21 SIR PETER BLAKE PARADE, BAYSWATER

SECTION 92 RESPONSE MATERIAL

21 JANUARY 2022

Resource consent application – Submission Points Further Information

Figure 1 Original vehicle tracking provided by Stantec of rubbish truck and car passing on bend.

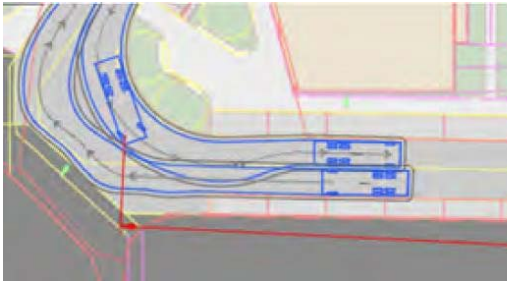
- a) *Please clarify how vehicles with boat trailers reverse onto the boat ramp safely. It is stated in the response that the widened flush median will facilitate these movements. Please provide vehicle tracking of an AT standard car and boat trailer reverse manoeuvring safely onto the boat ramp.*
- b) *The separation of the opposing traffic flows by line marking will assist with trucks crossing the centreline as they track around the bend. The original tracking provided by Stantec shows a rubbish truck entering the opposing lane by a significant margin. Please provide vehicle tracking showing a rubbish truck tracking around the bend with a car in the opposite direction to demonstrate both vehicles do not need to cross the centreline.*

Please provide a visibility assessment for the two proposed pedestrian crossings on the bend to ensure safe sight lines are achieved. This is critical for pedestrian crossing points.

**CAR AND BOAT TRACKING
APPENDIX B - SHEET 1 OF 3**

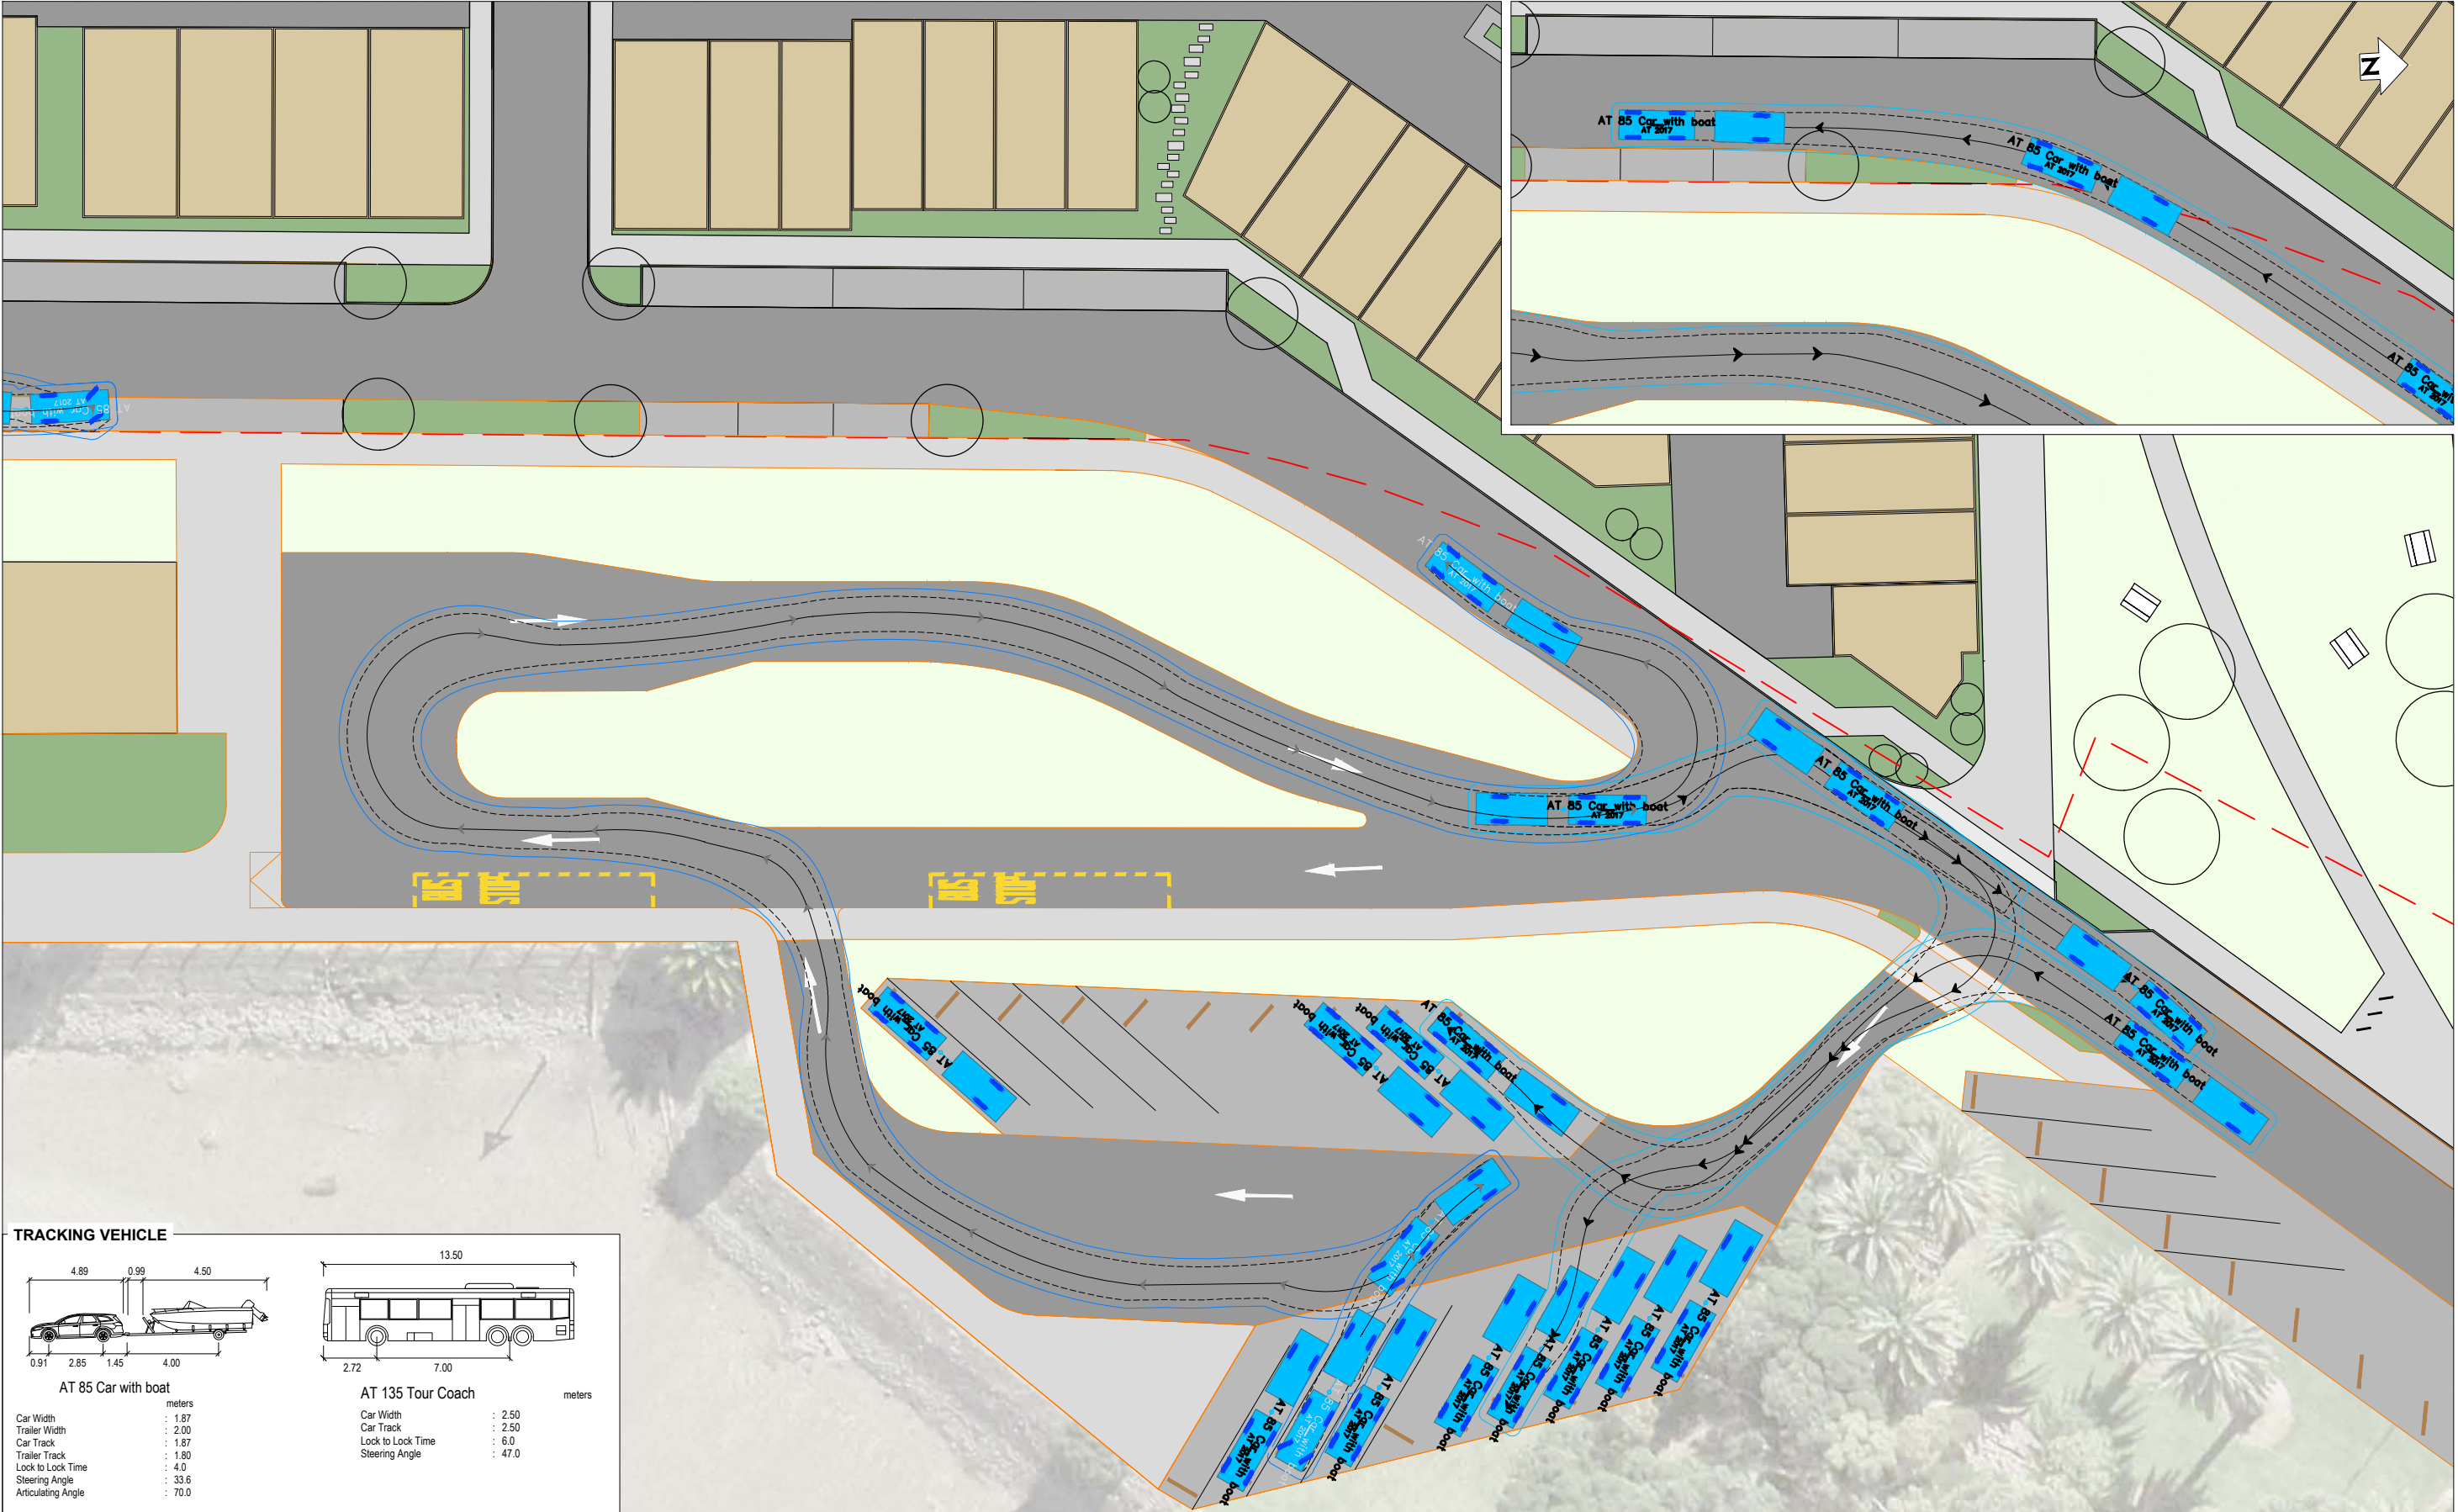
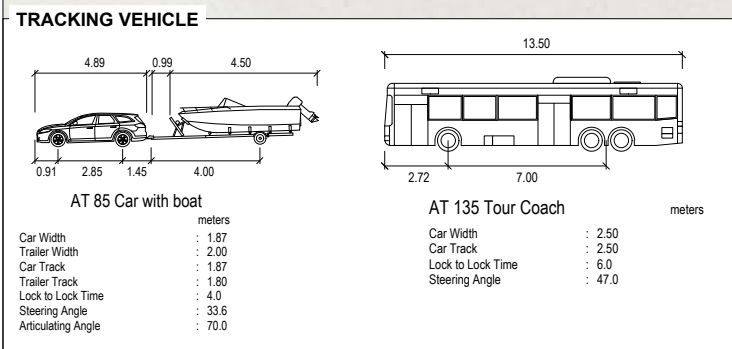
The access points are excessively wide at 7.5m for either one-way or two-way. Please confirm if the accesses are proposed to be one-way (as per the original Landscape Plans) or two-way as queried in the original s92 RFI. The tracking of the rubbish truck does not warrant the excessive width as shown in Appendix B Sheet 2 of 7 of the original ITA. The rubbish truck can take up the entire width of the crossing to enter and exit. Please consider narrowing the access points down to a maximum width of 6m.

Appendix B, Sheet 1 to 2 illustrates a car and boat trailer passing a refuse truck around the L-shape bend. As can be seen, the manoeuvres can be accommodated simultaneously.

This is the width is required to allow for the required tracking of a rubbish truck. Refer to Appendix B Sheet 2 of 7 of the ITA.

Design AW
Survey
Drawn ##
Checked ML
Date 13/12/2021
Scale 1:50 (A1) 1:100 (A3)
CAD Filename 12582-01-228.dwg
© Copyright 2021 Airey Consultants Ltd

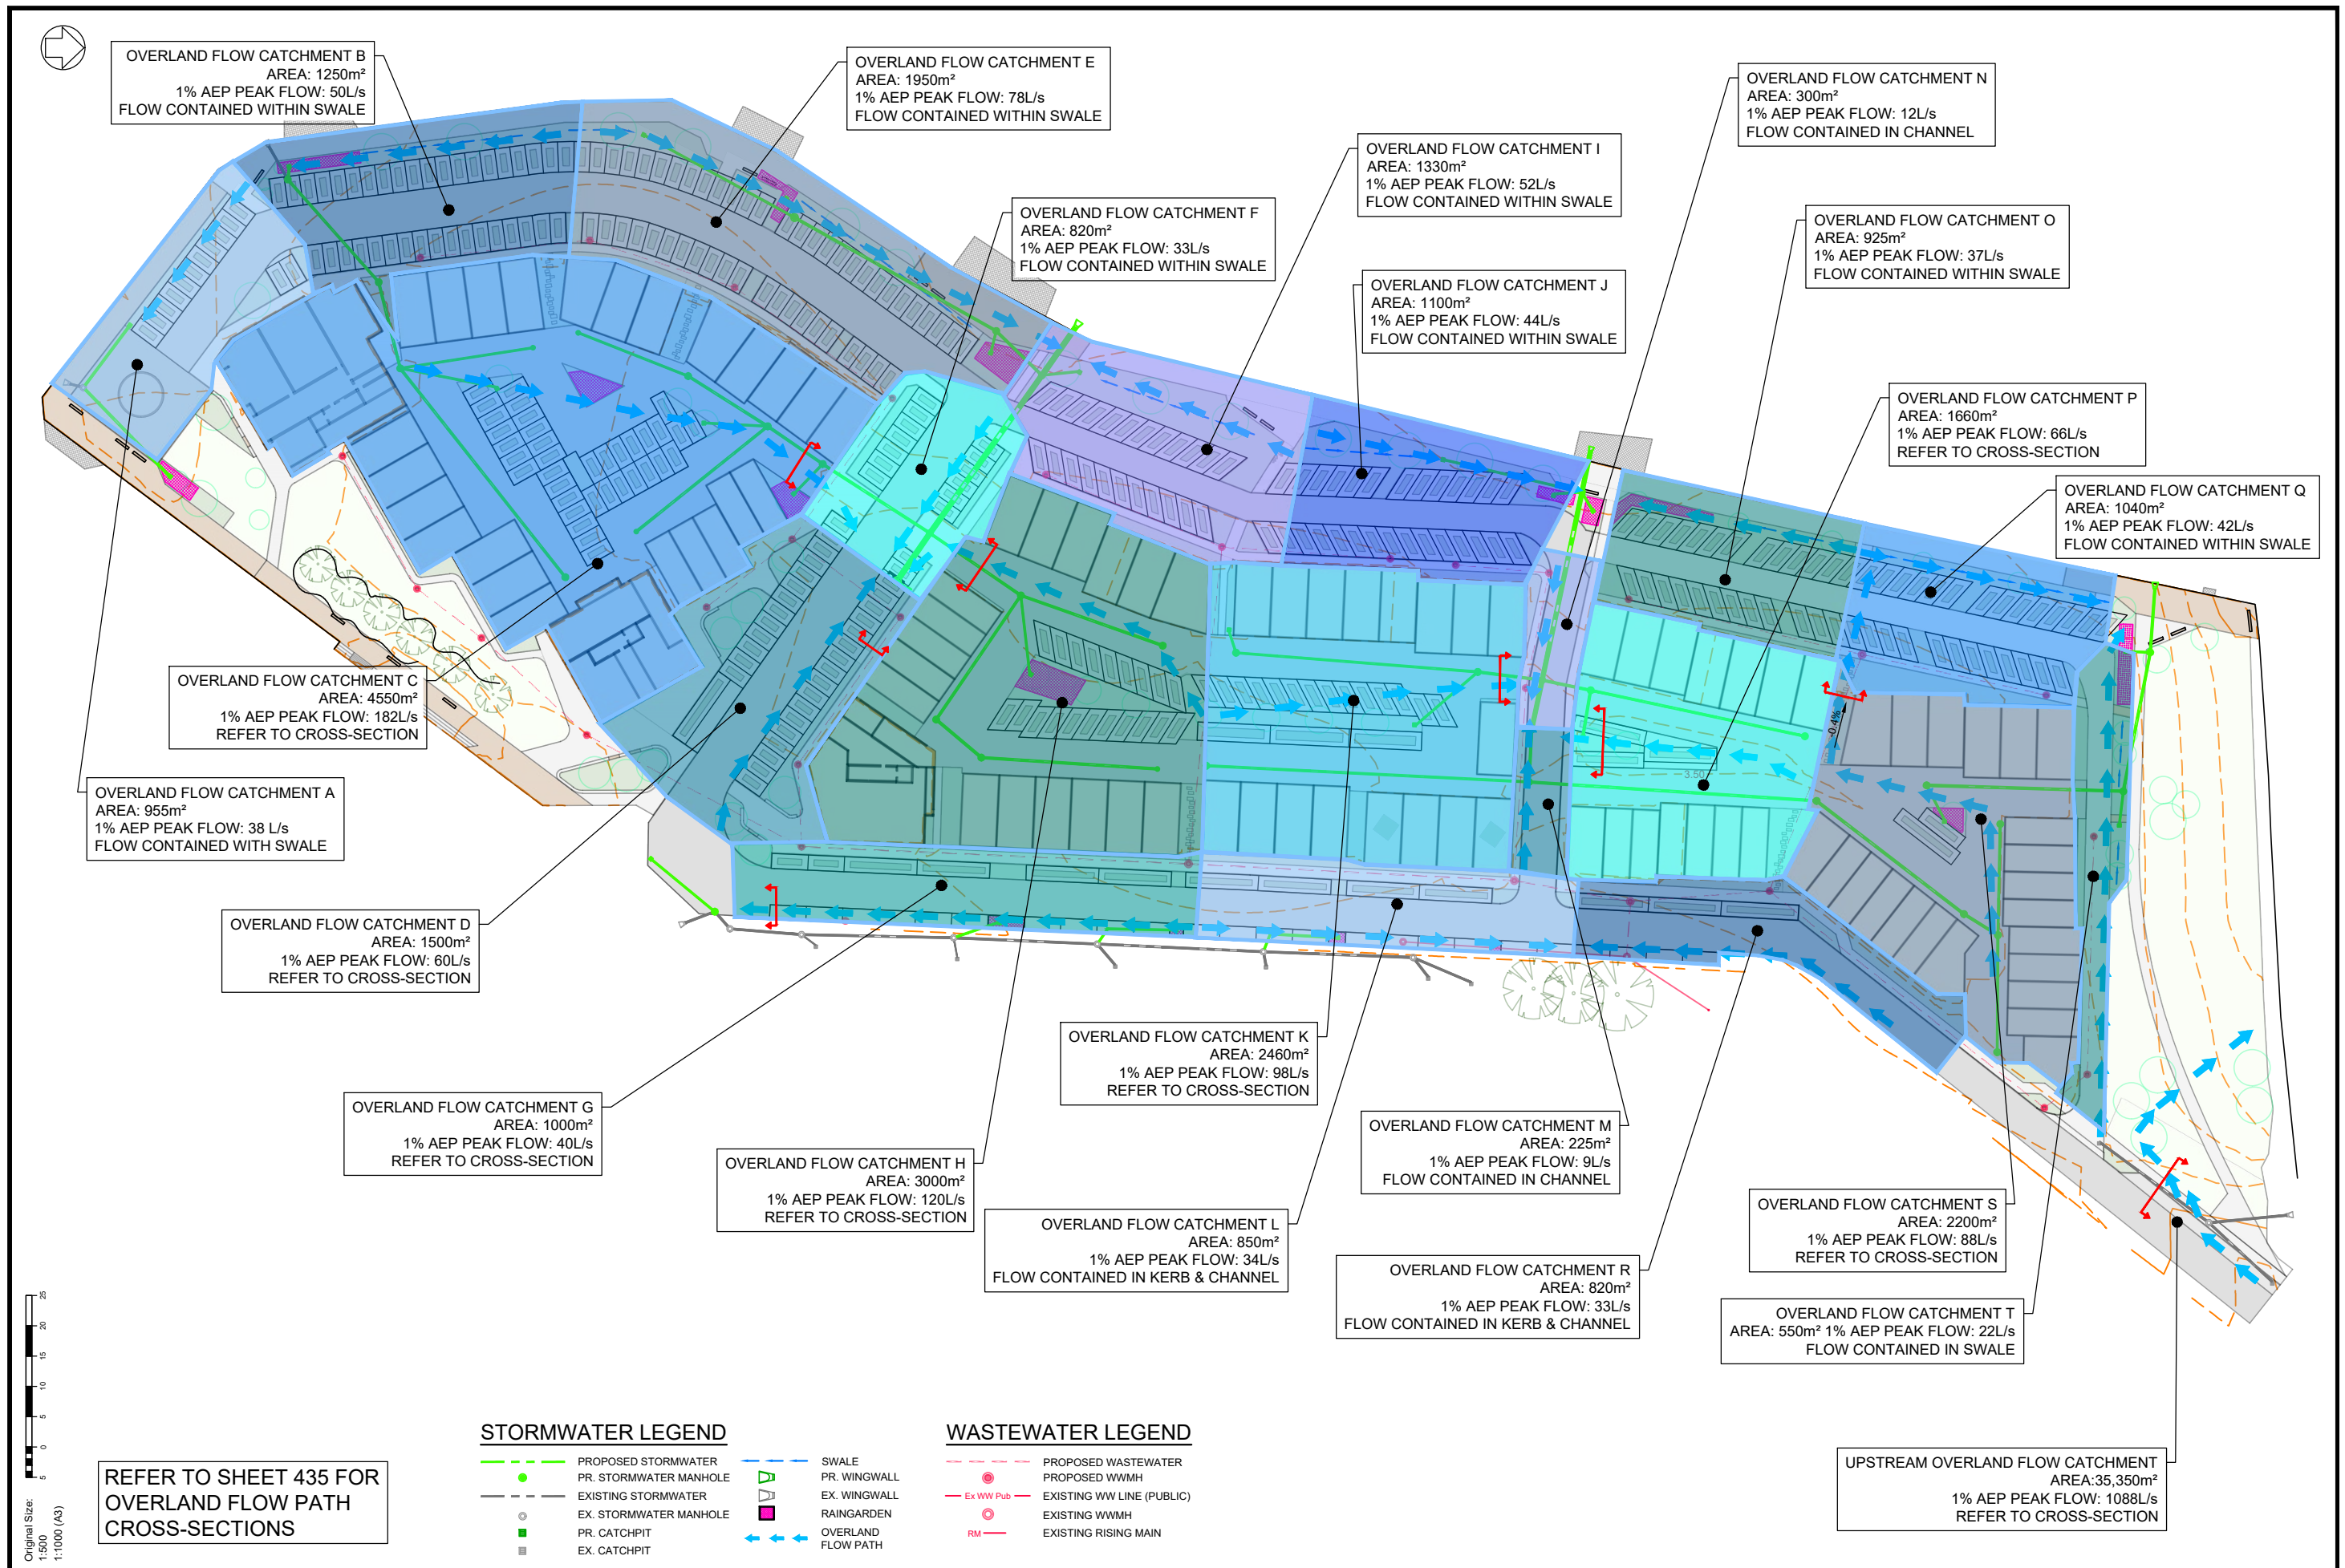
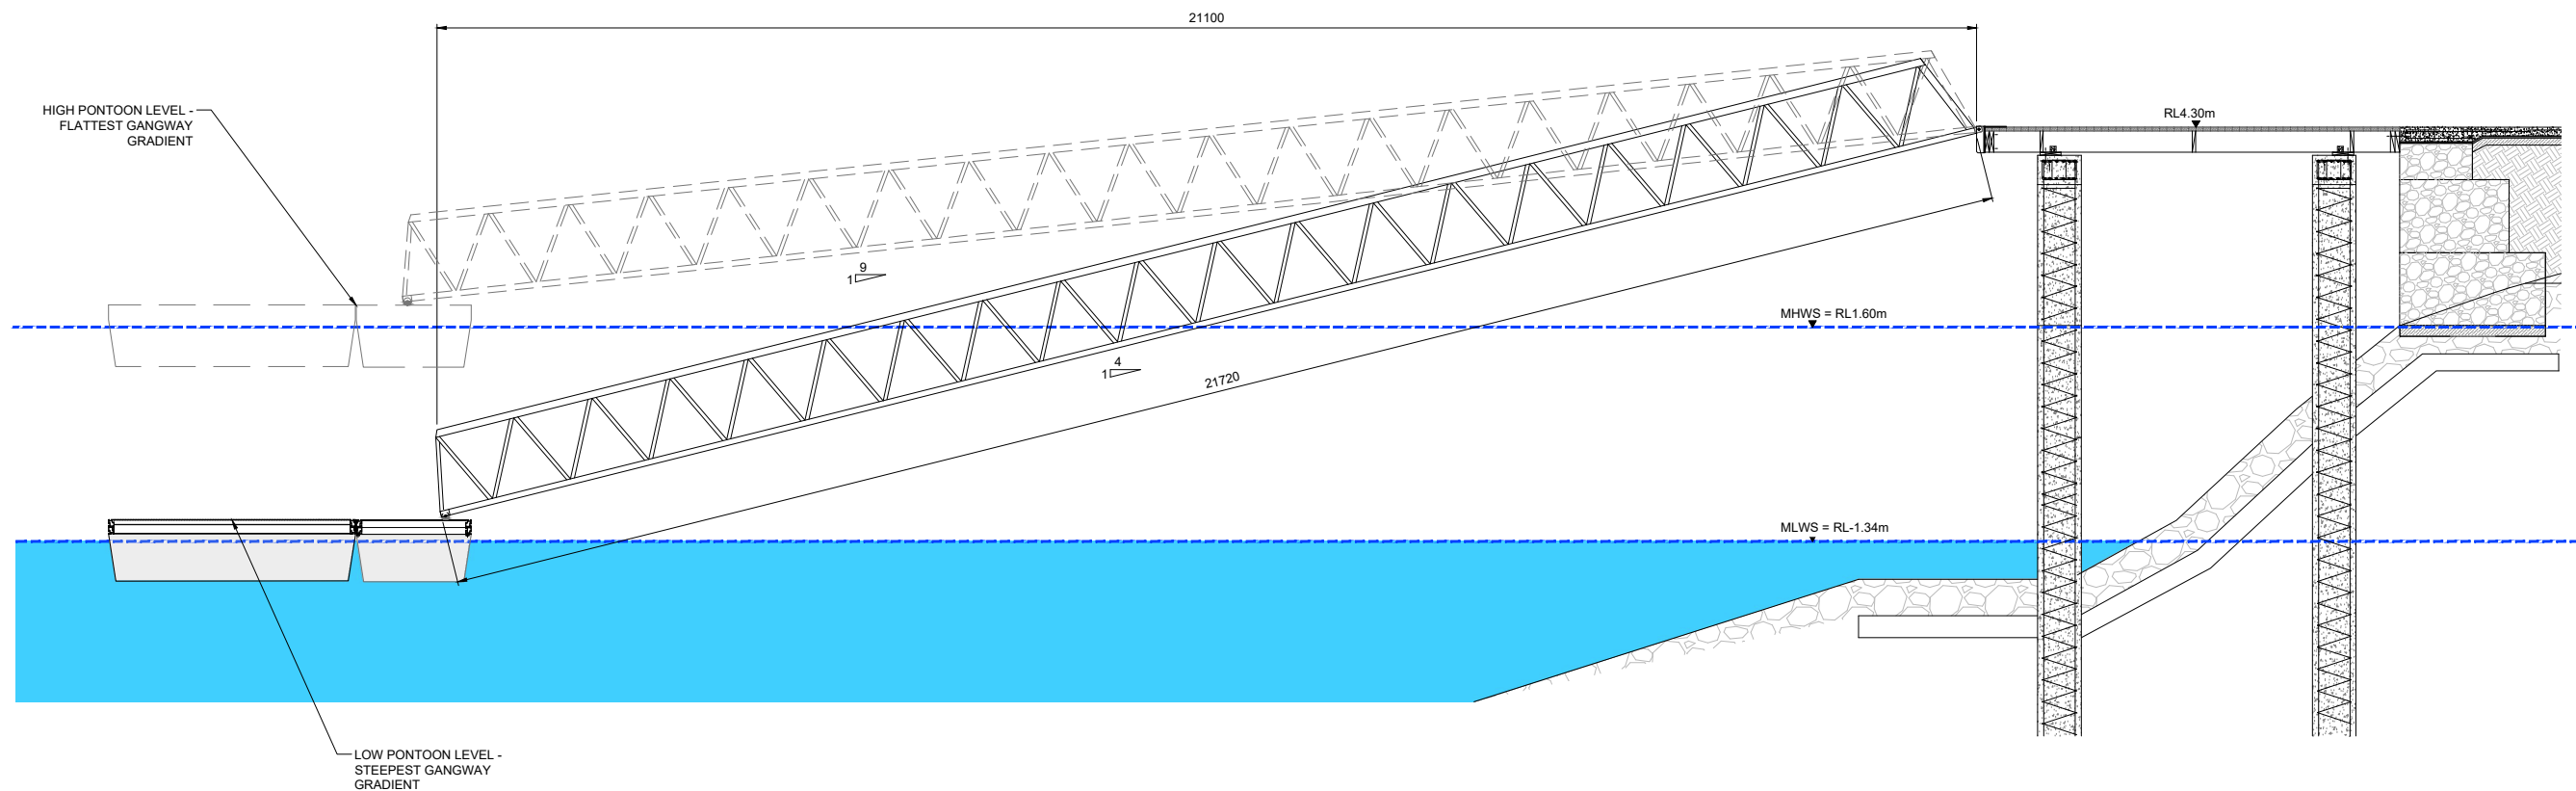
A number of submissions including the CC and BMBA query the works to the pier access points in terms of steepness and the lack of detail on this aspect of the interface with the marina in the future state. It would be helpful if BML could provide more detail on this matter so it is clear any extent of effect from the development on the access arrangements to the Marina.

Refer to the drawing 12582-01-228 attached. The design of the marina gangways has been undertaken in accordance with *AS 3962-2001 Guidelines for design of marinas*. The design has ensured that the gangway gradient at mean low water springs will be no steeper than 1:4. At mean high water springs the gangway gradient will be 1:9.

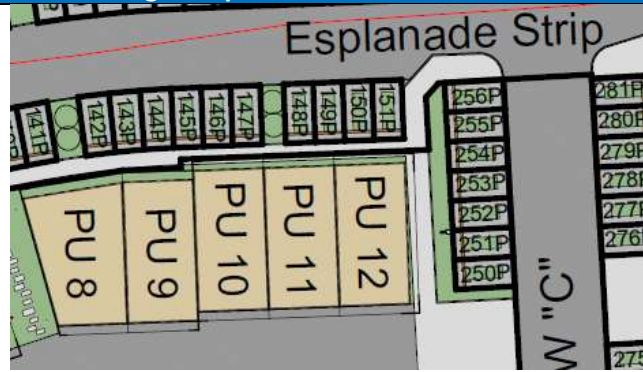
Council Review 1 August 2021	Urban Design Response 10 December 2021
	<p>These rules have been developed as part of a comprehensive planning and design exercise to ensures integrated development.</p> <p>This consistency and coherence at the macro level of form and location is complemented by deliberate visual diversity and variation at the level of detail (see R3.1). But that diversity is also within limits and is controlled. That is, guidelines G3.1, G3.2 and G3.3 address architectural design coherence, character and relation to neighbouring dwellings respectively and combine to give a high degree of certainty on a coherent and fit for place outcome.</p>
<p>Q46 Projections into Esplanade Strip</p> <p>Thank you for this information provided, it is also noted that the esplanade strip has been adjusted from that previously provide in Scheme Plan NA639741 Rev 6 and effectively means that balconies and steps are likely to be located on or over common property and will not extend into the esplanade strip. However, there are still concerns that balconies and steps may intrude into the esplanade strip, which would be a planning issue, the effects of these on the western foot pavement which extends Sir Peter Blake Parade also needs to be considered. The key areas which need confirmation are illustrated below, in particular the need for sufficient space to accommodate the steps and footpath?</p>	<p>Projections into Esplanade Strip (Hampsons advise that no part of a building or its projection extends over the esplanade strip.)</p> <p>Front entry stair projections</p> <ul style="list-style-type: none"> • The Design Manual (R2.14) identifies some units that may include steps within the common property. These lots are identified in Appendix 1 Table 2, and for avoidance of doubt recorded also in R2.14 (a). The lowest stair riser is required by R2.14 (c) to be set back not less than 450mm from the back of the footpath. • Auckland Council has illustrated some of the PUs where stairs are permitted. Given the minimum setback required from the footpath by R2.14 (c) it is confirmed that there is sufficient space to accommodate the steps and the footpath.

- Any balcony on the identified west façade of any of PU 10-12 will not overhang the footpath.
